DCA01MA034

Air Traffic Group Factual Report of Investigation

Attachment 8 – Procedures Data, pre-1991, 21 pages

SUBJECT: Public Use VOR/DME-C Instrument Approach to Aspen-Pitkin County/Sardy Field Airport, Aspen, Colorado

VOR DME-C

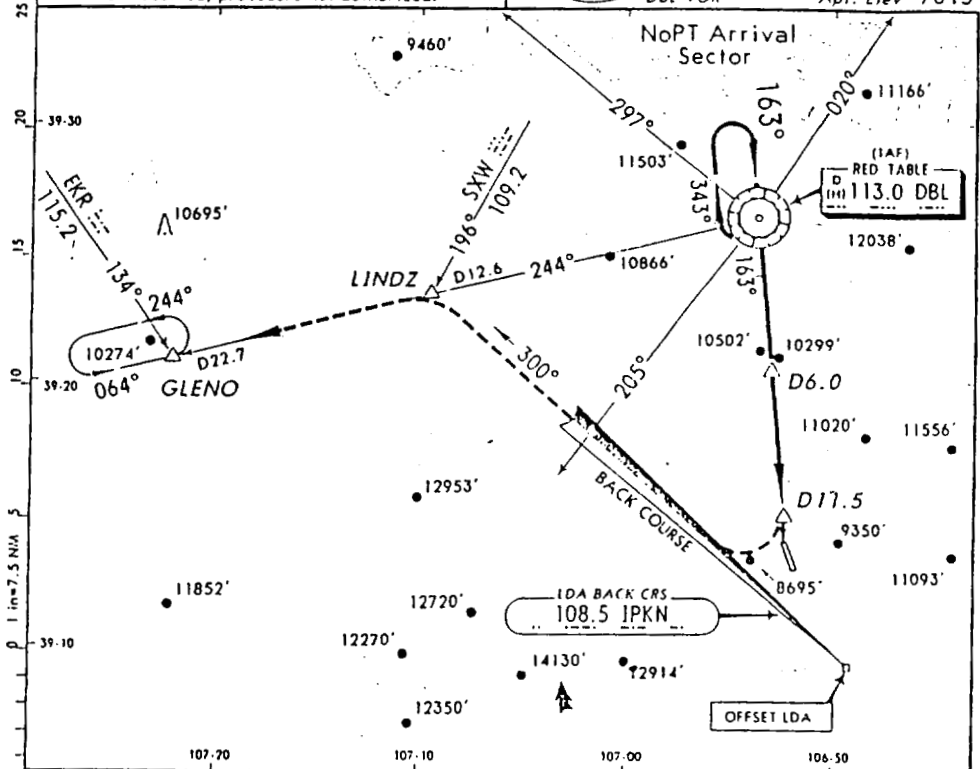
1. Relocate the FAF to DBL 5 DME.
2. Name the FAF. "ALLIX" has been pre-coordinated.
3. Provide a stepdown fix in the final approach segment, approximately
midway between the FAF and the MAP.

It appears that a significant reduction in minimums might be achieved if the
FAF were located at 5 DME and a stepdown fix were added to the final.

Please remove the note restricting night operations from the Aspen,
Colorado VOR/DME-C public procedure.

Night minimums at Aspen-Pitkin/Sardy Field, CO have been denied IAW Order 8200.1, Para 214.43, Order 8260.19A, Para 110 and Order 8260.3B. Day operations in and out of Aspen are difficult under the best of circumstances. Night operations would present an unjustified degradation in safety. Order 8200.1, Para 214.43 states, "For original procedures at airports having no prior IFR service, a night flight inspection will be conducted to determine the adequacy of airport light systems prior to authorized night minimums." Not a single Flight Inspection pilot in this office will conduct the flight at night in order to remove the restriction. Given the extremes of weather, terrain and available ground reference lighting it is the firm belief of both the Flight Inspection Section and involved Procedures personnel that approval of night operations at Aspen presents a hazardous situation for the general public.

Subject: ASPEN, CO., VOR/DME-C

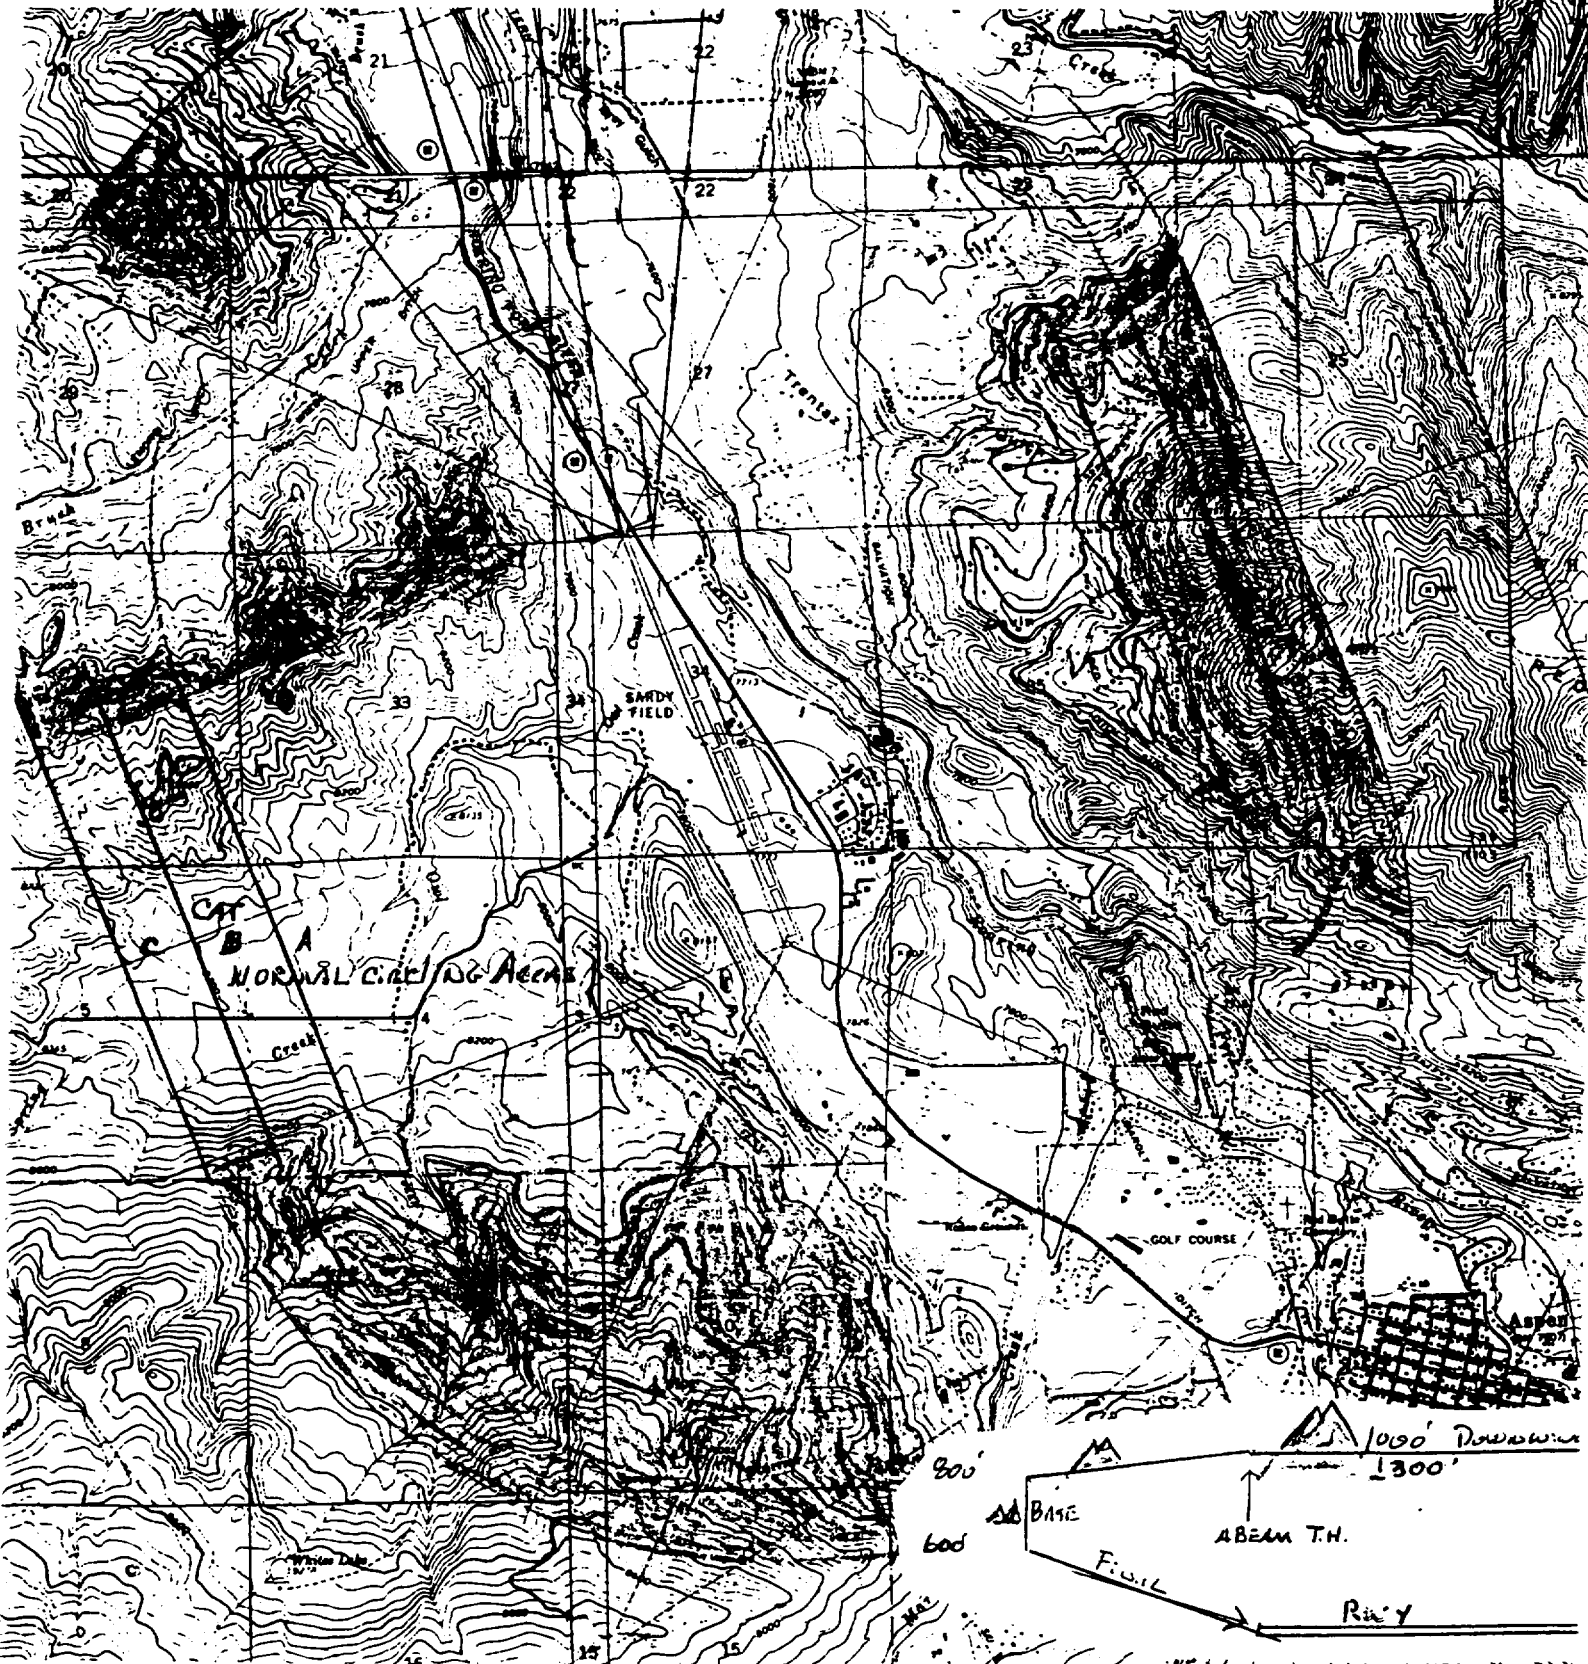
The present minimums for the VOR/DME-C, Amdt 3 at Aspen, CO are a result of the missed approach obstacle identification surface and charted controlled airspace. A control zone exists at Aspen, however it was charted for the old NDB-A SIAP. This control zone is not adequate for the VOR/DME-C approach. If in the future, airspace were to be revised to add a new key to encompass Red Table VOR/DME it is possible that lower minima could be achieved. Preliminary "ROC" studies indicate that the missed approach will continue to control procedural minima.

REASONS FOR DISALLOWING HIS PROCEDURE AT NIGHT:

- 1-Pilots are trained to fly standard patterns at unfamiliar airfields. A standard pattern consists of 1000ft above airport elevation on downwind, start descent when abeam the intended point of touchdown, continue downwind until 45° beyond the threshold and approximately 200ft lower than downwind, turn base and continue descent until lined up for final and approximately 500 to 600ft above airfield elevation.
- 2-Flying a standard pattern at this airport would put the aircraft below ground level in the areas colored red, and leave it with insufficient terrain clearance in the areas colored in yellow.
